Hope Creek Generating Station
Renewed Facility Operating License No. NPF-57
NRC Docket No. 50-354

Subject: Hope Creek Generating Station Compliance with NRC Order to Modify
Licenses with Regard to Reliable Spent Fuel Pool Instrumentation
(Order EA-12-051) and Responses to Requests for Additional Information

**Hope Creek Generating Station Response to Interim Staff Evaluation and
Request for Additional Information Regarding the
Overall Integrated Plan for Implementation of
Order EA-12-051 "Reliable Spent Fuel Pool Instrumentation"**

Figure	Description
1a	Section View – West Probe
1b	Section View – Northeast Probe
2	Mounting Plate Detail
3	Plan View – Northeast Probe
4	Plan View – West Probe

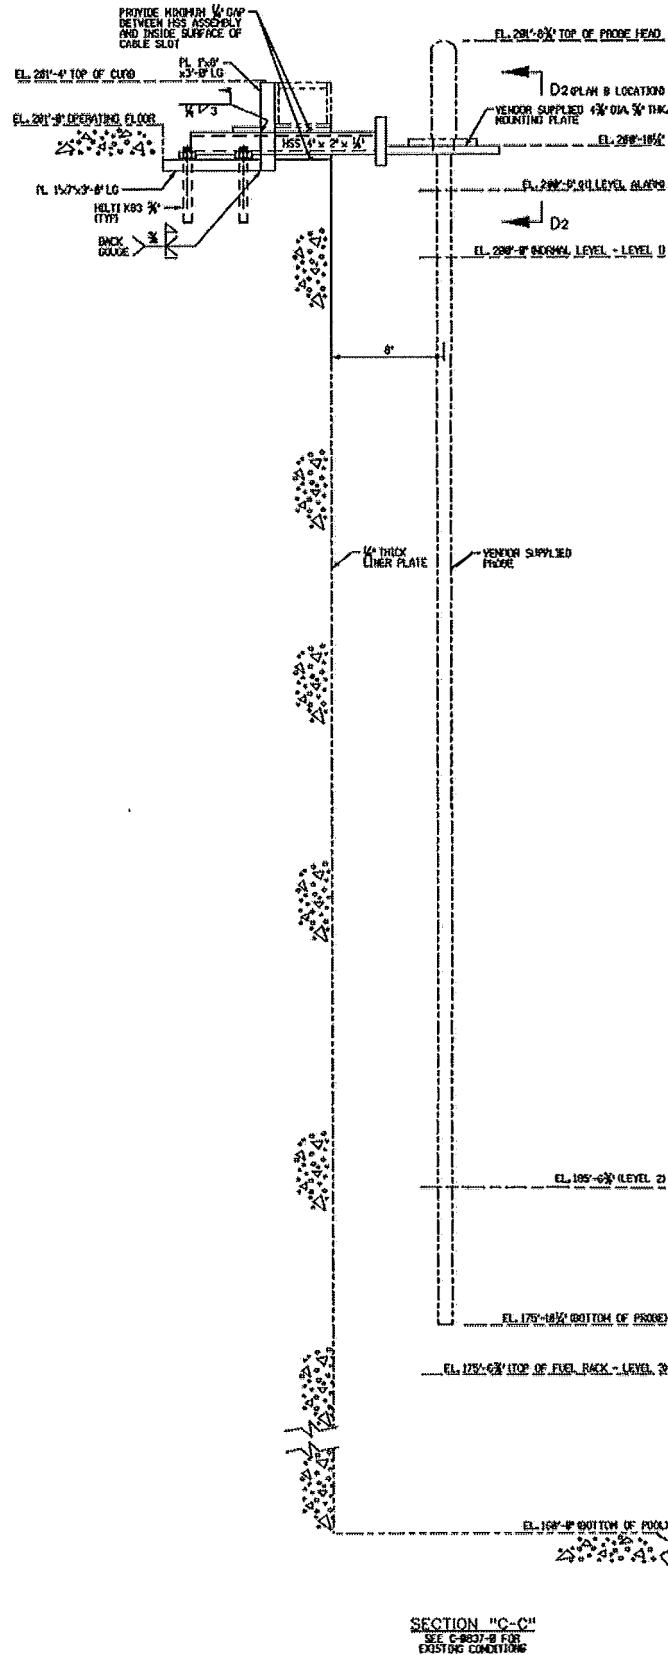
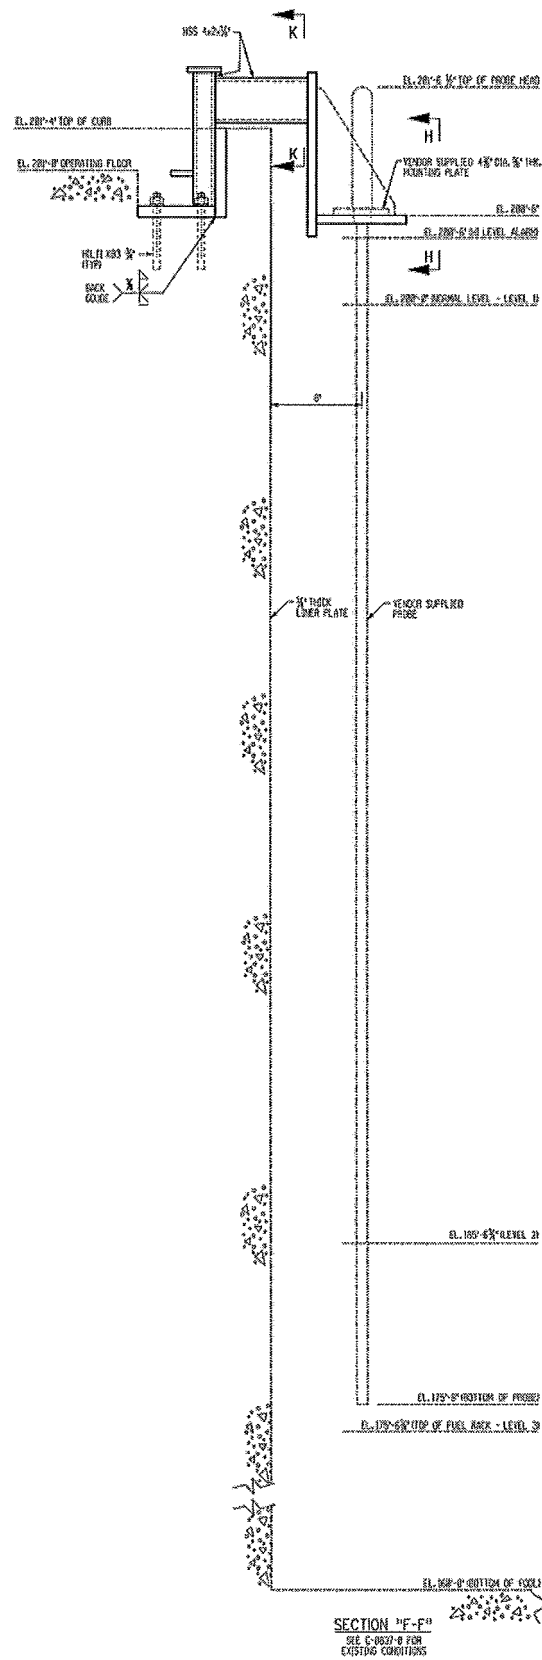
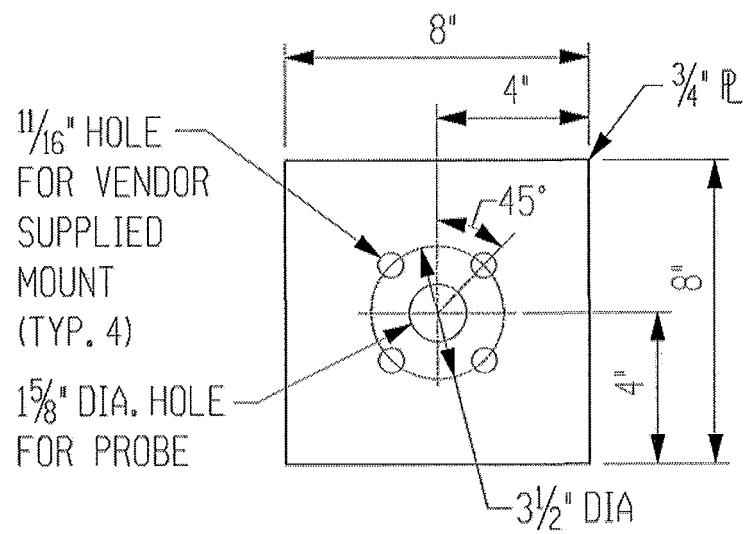
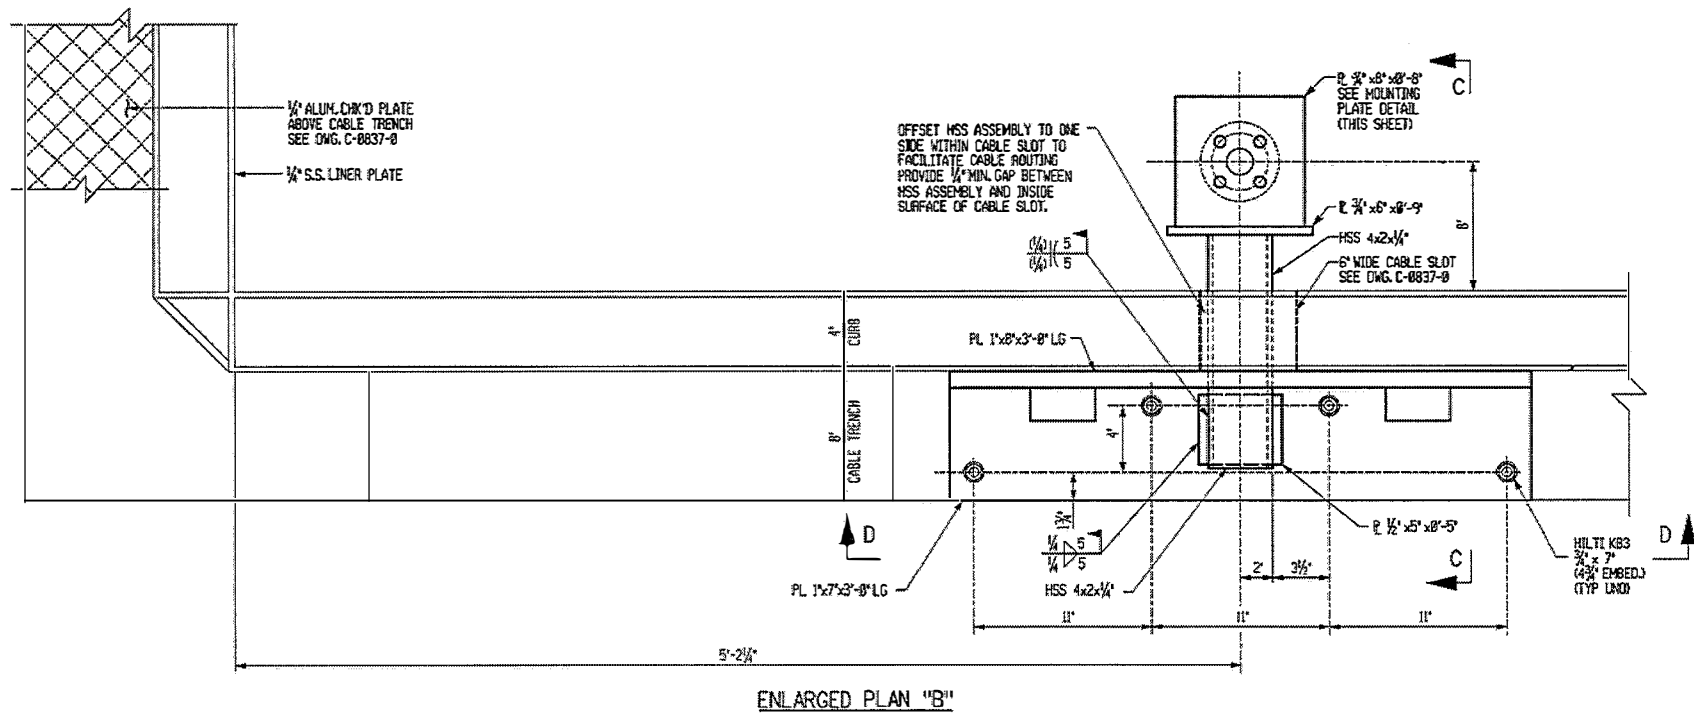
RAI #1

- a) The design criteria that will be used to estimate the total loading on the mounting device(s), including static weight loads and dynamic loads. Describe the methodology that will be used to estimate the total loading, inclusive of design basis maximum seismic loads and the hydrodynamic loads that could result from pool sloshing or other effects that could accompany such seismic forces.
- b) Indicate in a schematic, the portions of the level sensor that will serve as points of attachment for mechanical/mounting or electrical connections.
- c) A description of the manner by which the mechanical connections will attach the level instrument to permanent SFP structures so as to support the level sensor assembly.

- b) The support structures are anchored to the concrete curb around the SFP above the refueling deck as shown in the following figures:

- c) The level sensor is designed to be attached near its upper end to the support structure as shown in Figures 1a, 1b, 2, 3, and 4.
